CSVSWRA – Review Comments on 2023-11-27 Submission documents.

Date: March 8, 2023

Figure 1. Climate Variations in Toronto (source: Forest and Field Landscape Architecture Inc.)

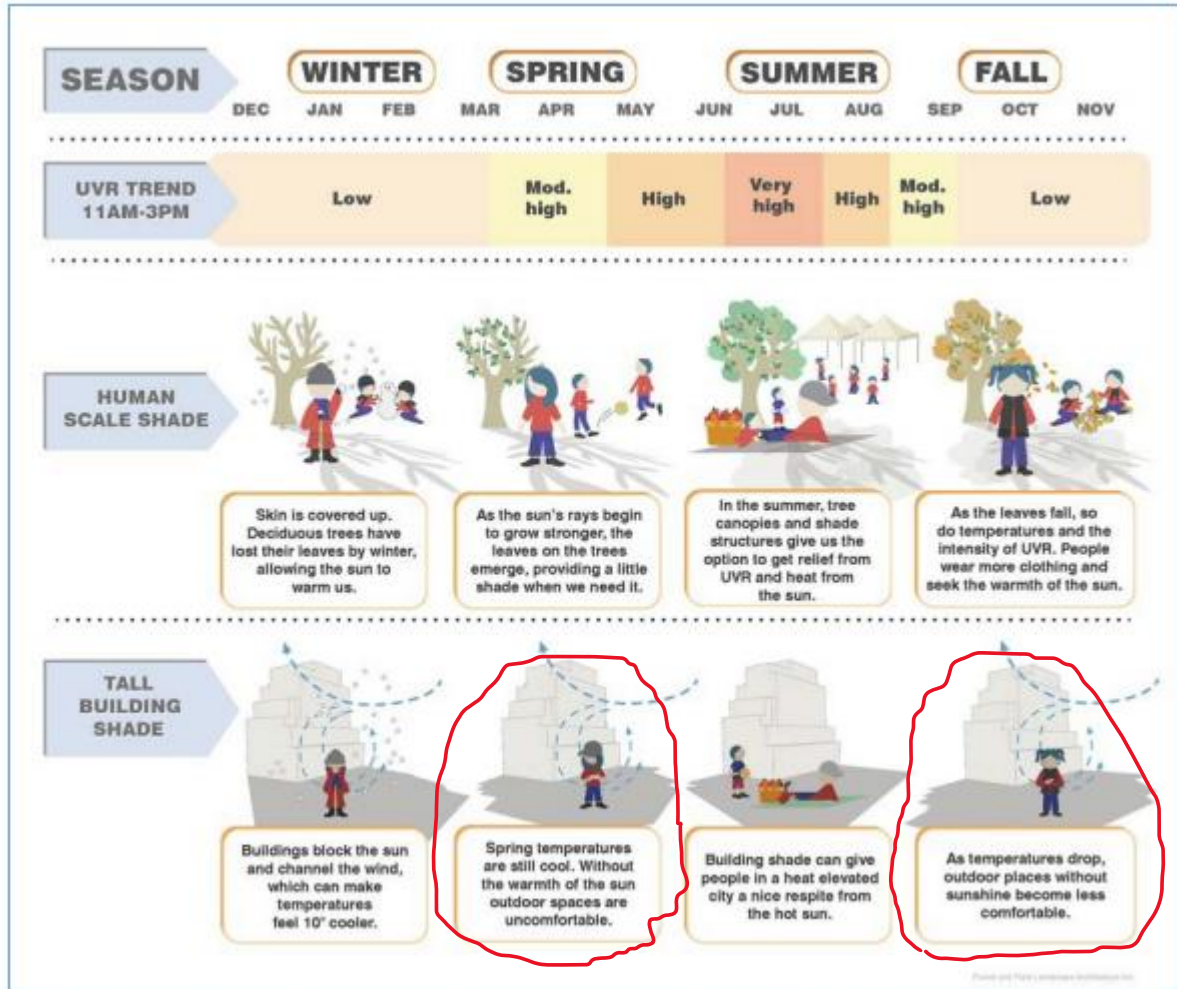
The shadow study for September 21 (similar on April 21) shows the rear yards of 6 & 8 Windy Ridge and 4 homes on Whitecap Blvd. and the open space parkland area for 3311 Kingston Rd. all in shadow at 6:18pm, resulting in uncomfortable outdoor spaces (see Figure 1 -chart below)
